Dr. Sönke Johnsen, Ph.D
Professor of Biology, Duke University

PSA equations for heating and cooling

Application for Certification for the HIDDEN)
HILLS SOLAR ELECTRIC GENERATING) Docket No. 11-AFC-2
SYSTEM PROJECT)
_____)

Spectra of sun and feather heated to 200 C

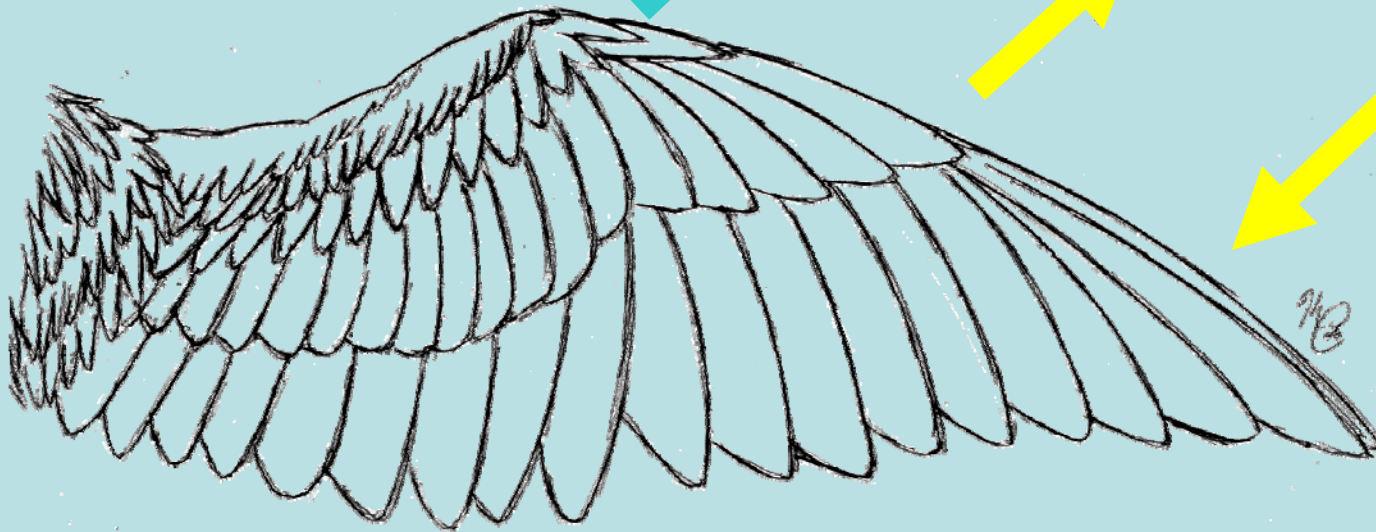
does $\alpha = \varepsilon$?

nearly all < 2um

nearly all > 2um

$$\alpha \neq \varepsilon$$

First correction of equations

$$Q_{SF} \cdot VF \cdot \alpha_{sol}$$

View Factor

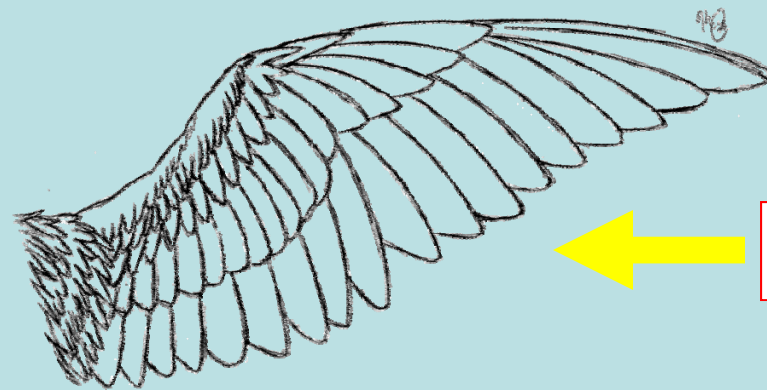
← (VF = 1)

← (VF = 0.342)

α_{sol}	Absorptivity correction	View Factor VF = 0.342			
0.95	4.7 From PSA	14			
0.65	6.9	20			
0.75	6.0	17			
0.85	5.3	15

Heat Transfer Coefficient h_c

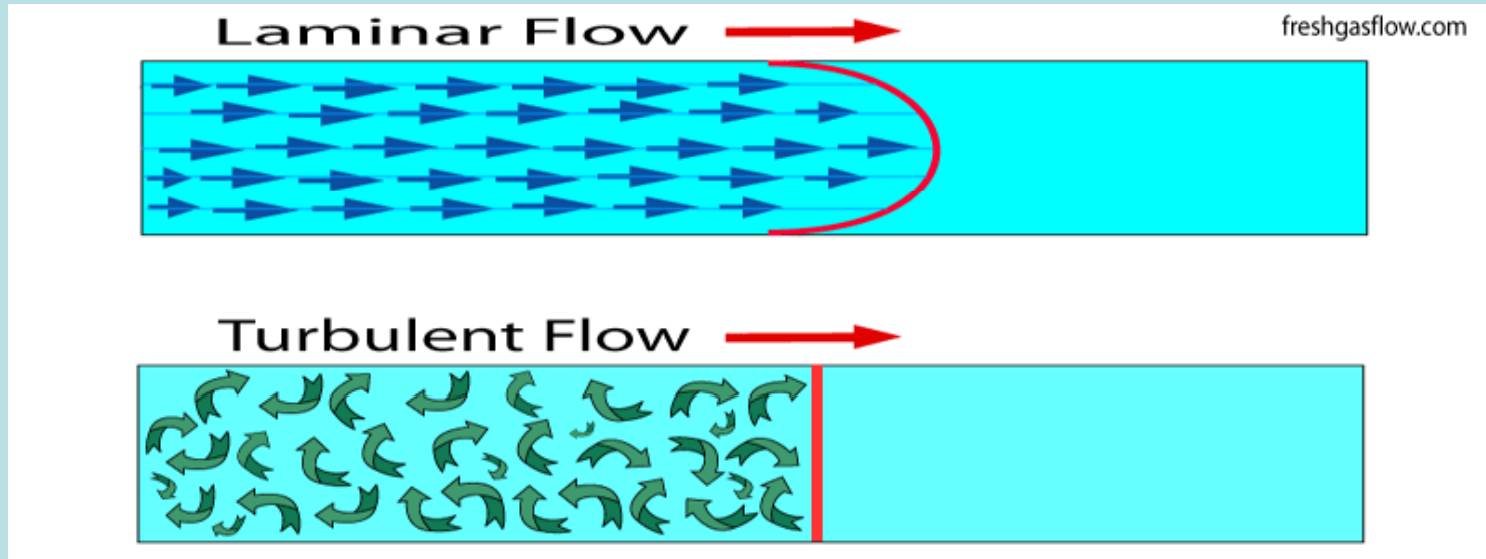
Laminar

$$h_c = \frac{k_{air}}{L} Nu = 0.0592 \frac{k_{air}}{L} (Re)^{4/5} \sqrt[3]{Pr} \cong 71.8$$

Turbulent

$Re = \sim 68,000$ --- Turbulent flow

α_{sol}	Absorptivity correction	View Factor VF = 0.342	Heat Xfer Coef. $H_c = 71.8$		
0.95	4.7 From PSA	14	29		
0.65	6.9	20	42		
0.75	6.0	17	36		
0.85	5.3	15	32

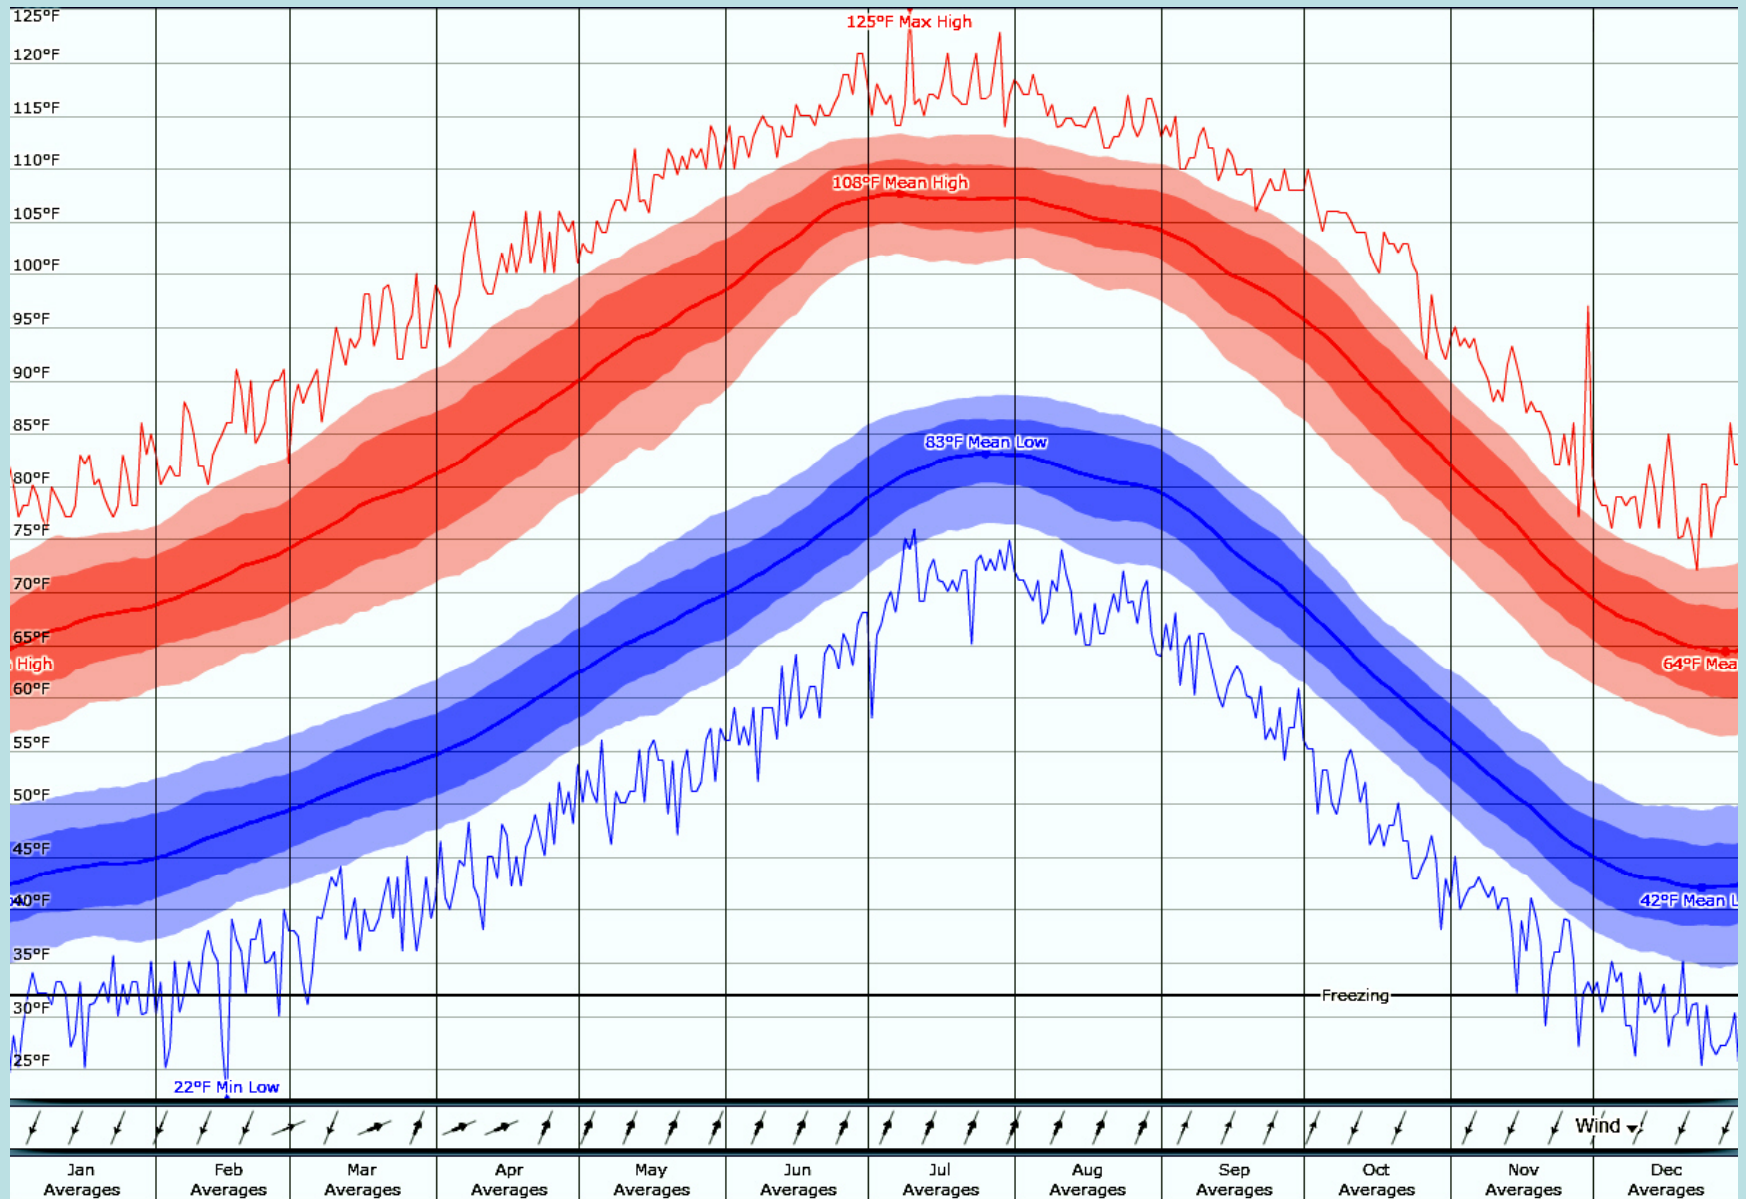
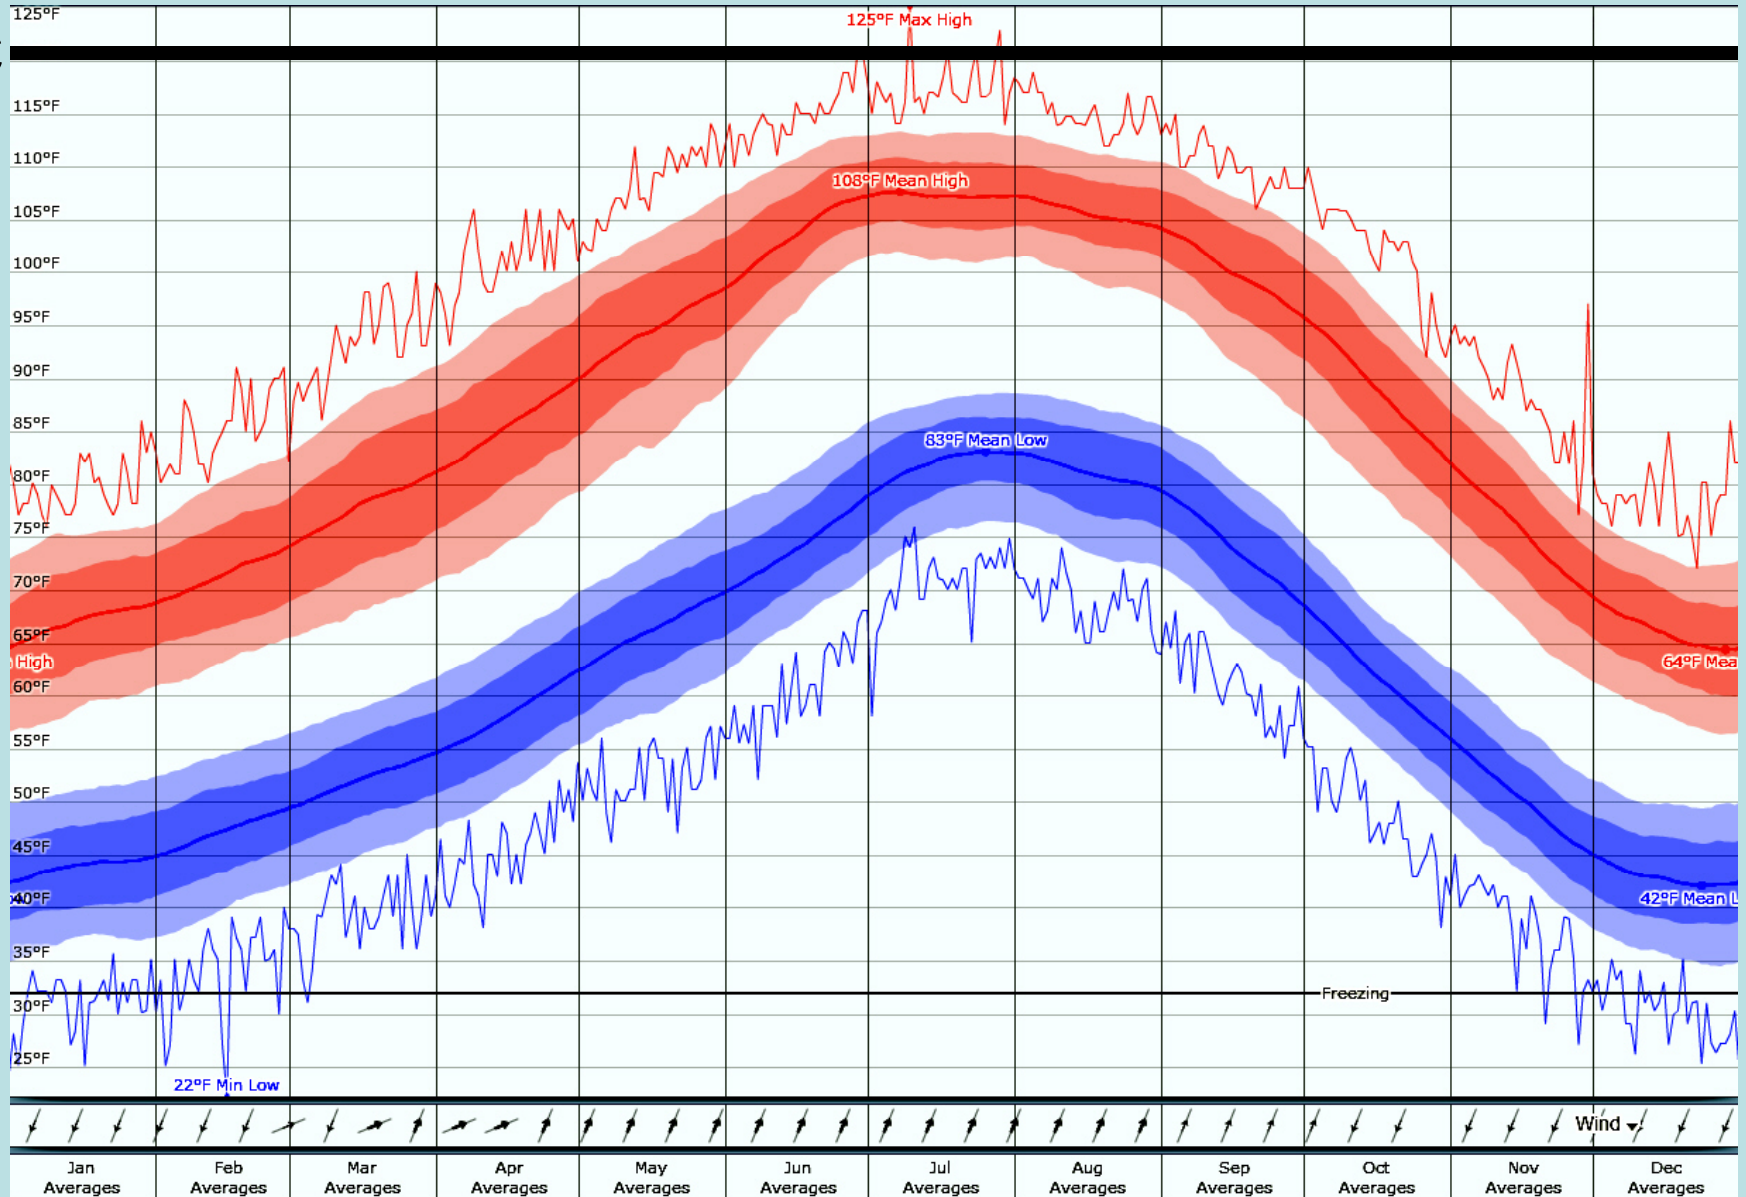
T_{air} = 49 C?

49 C

49 C
45 C

α_{sol}	Absorptivity correction	View Factor VF = 0.342	Heat Xfer Coef. $H_c = 71.8$	Ambient Air $T_{air} = 45\text{ C}$	
0.95	4.7 From PSA	14	29	29	
0.65	6.9	20	42	43	
0.75	6.0	17	36	37	
0.85	5.3	15	32	33

Radiative temperature versus Air temperature

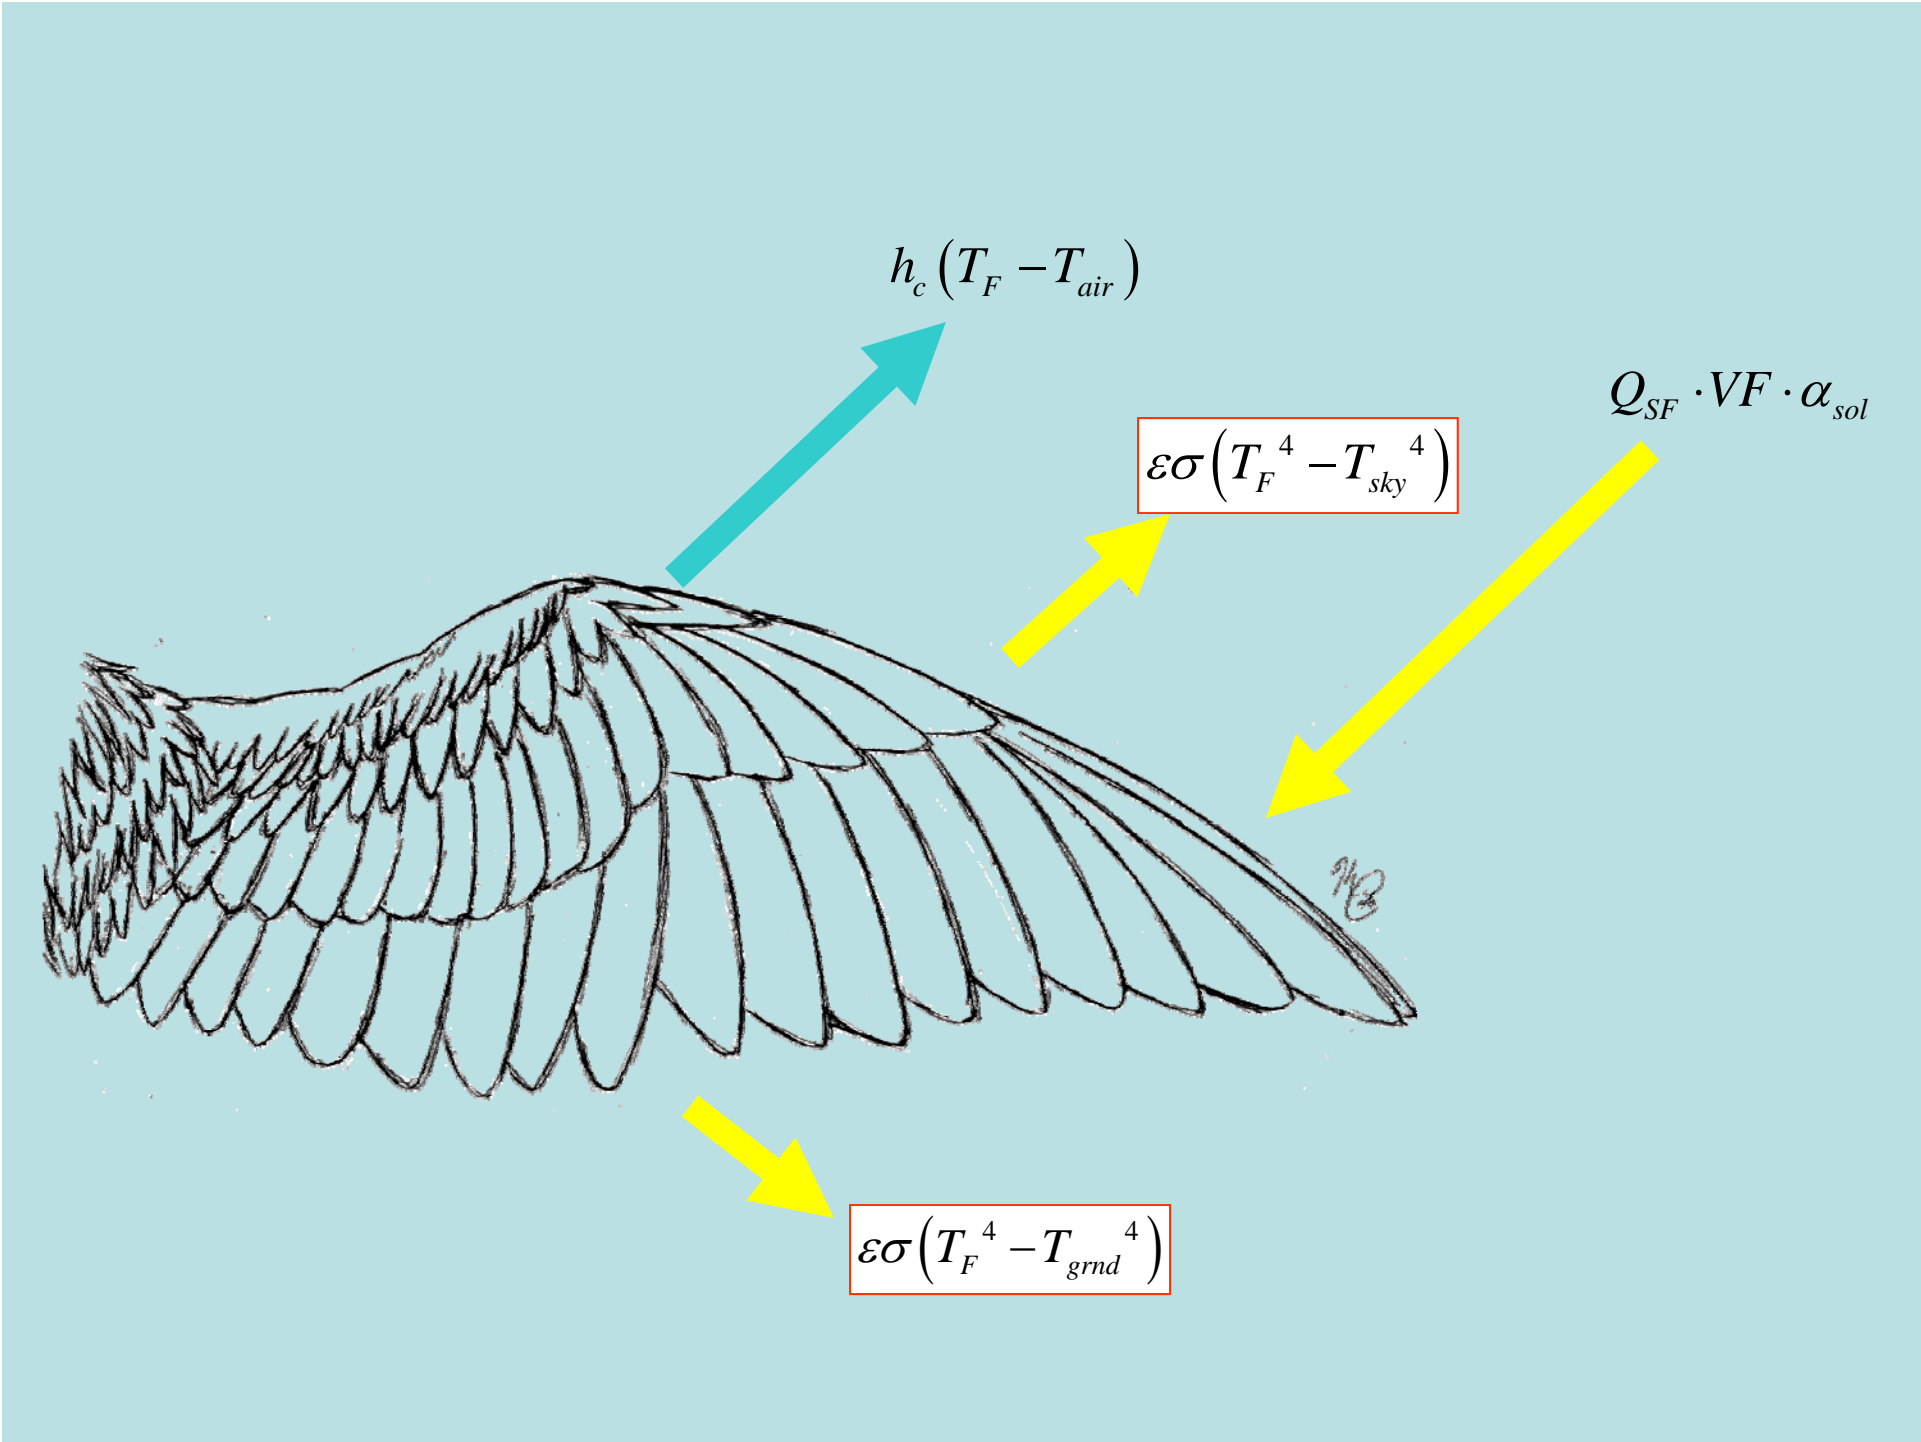
$$\varepsilon\sigma (T_F^4 - T_{sky}^4)$$

$$\varepsilon\sigma (T_F^4 - T_{grnd}^4)$$

α_{sol}	Absorptivity correction	View Factor VF = 0.342	Heat Xfer Coef. $H_c = 71.8$	Ambient Air $T_{air} = 45\text{ C}$	$T_{sky} = 0\text{ C}$ $T_{grnd} = 45$
0.95	4.7 From PSA	14	29	29	34
0.65	6.9	20	42	43	50
0.75	6.0	17	36	37	44
0.85	5.3	15	32	33	39

Wings Flap!

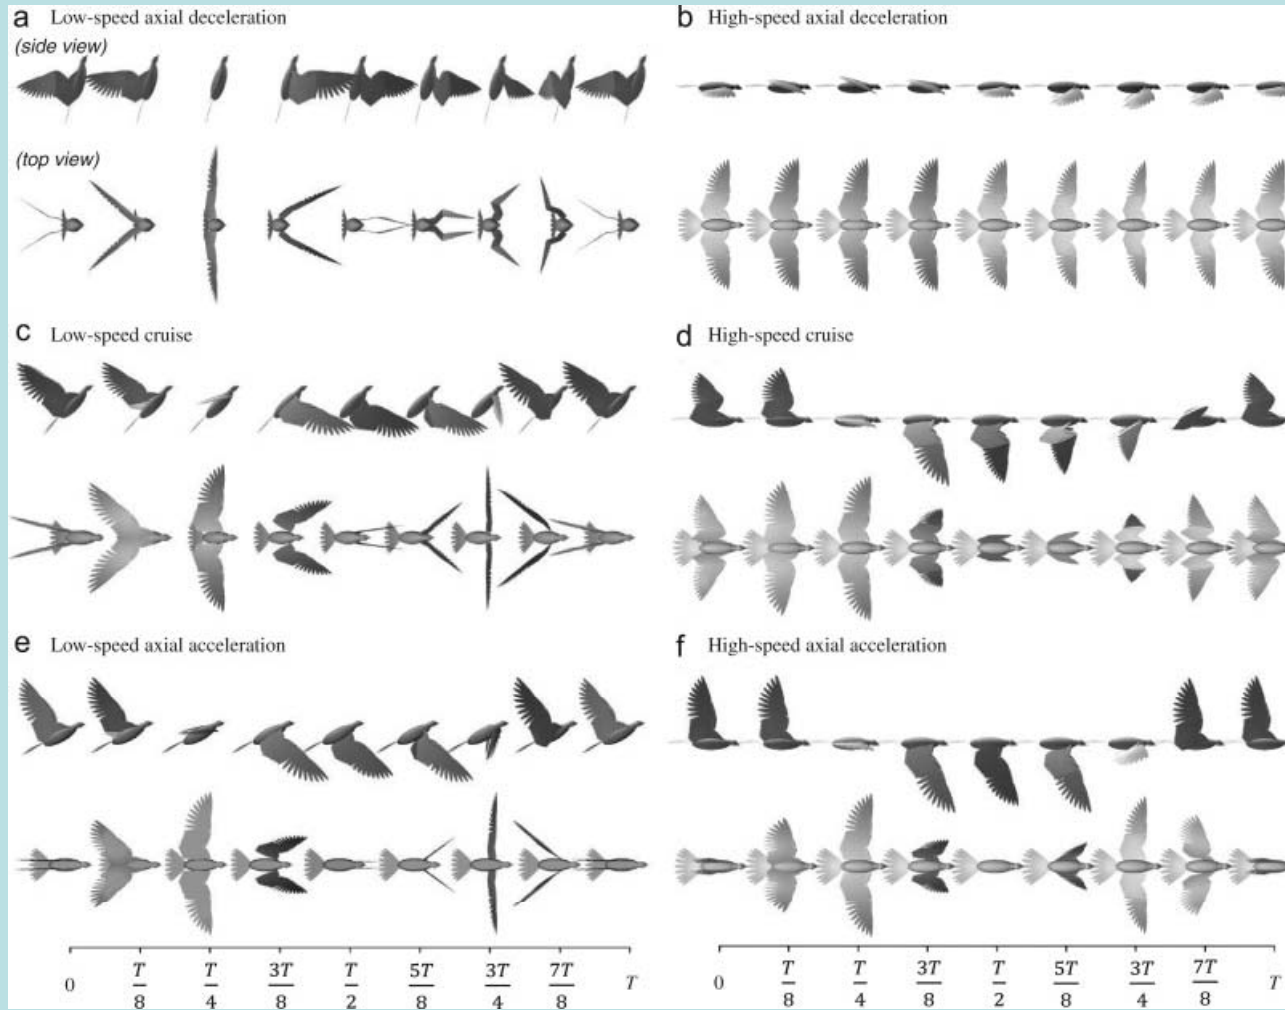
- Equations presented in the PSA are incorrect.
- Revised analysis presented here represents a reasonable, yet very conservative lower bound for flux effects.
- Wing flapping may significantly effect the heat transfer coefficient further reducing potential for flux effects.
